**NOTICE OF PUBLIC MEETING  
BUILDING AND ZONING COMMITTEE  
LOCATION: TOWN HALL, 50 COLONY ROAD  
DATE AND TIME: WEDNESDAY, MARCH 20, 2024 AT 5:00 PM**

6. Continued Items:
  - A. #20 Ocean Drive: new two-story residence with outdoor pool. Total under air: 6,834 sf. Total square footage: 9,768 sf. Lot occupancy calculation: 47.97% (50% allowed). Maximum building height: 25' (25' allowed).

- B. #34 Ocean Drive: new two-story residence with outdoor pool. Total under air: 3,795 sf. Total square footage: 4,637 sf. Lot occupancy calculation: 49.29% (50% allowed). Maximum building height: 24'-11¼" (25' allowed).

Jupiter Inlet Colony Plan Review

Sheet No.  
**S3**  
NOT FOR CONSTRUCTION  
DATE: 2-27-24

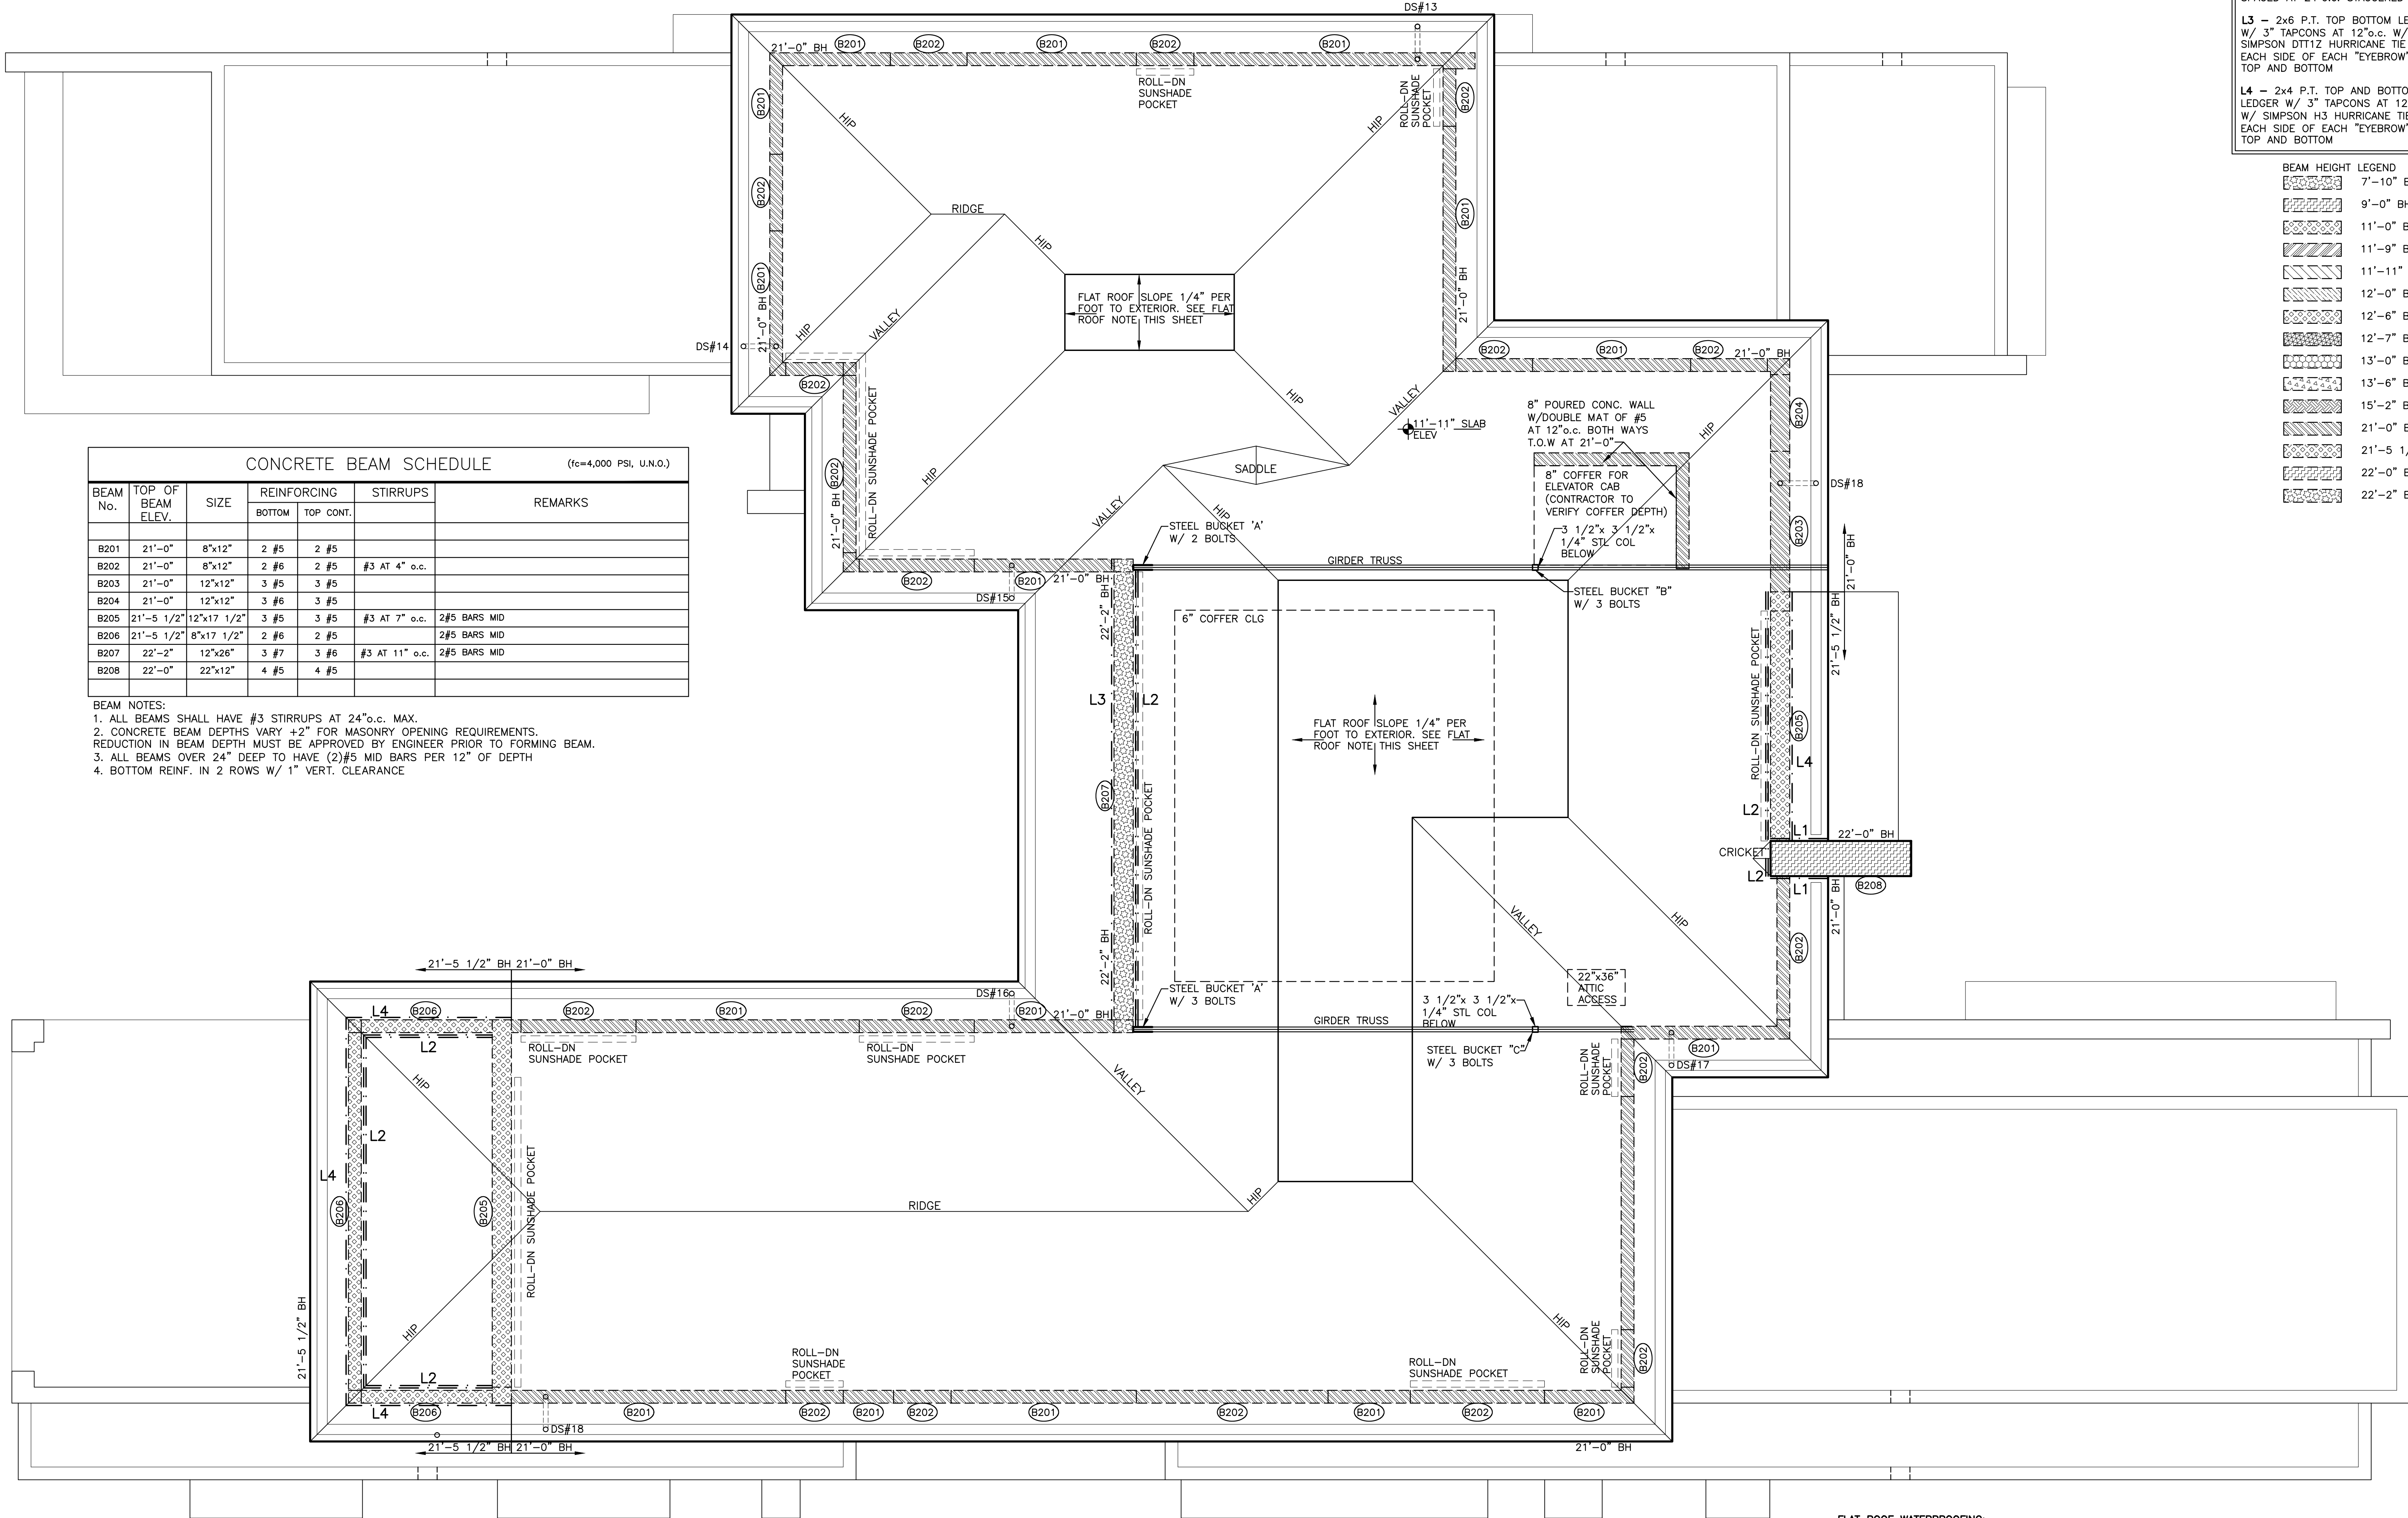
- Extended the Summer Kitchen eastward approx. 8'
- Provided structure for the newly added storage mezzanines in both garages
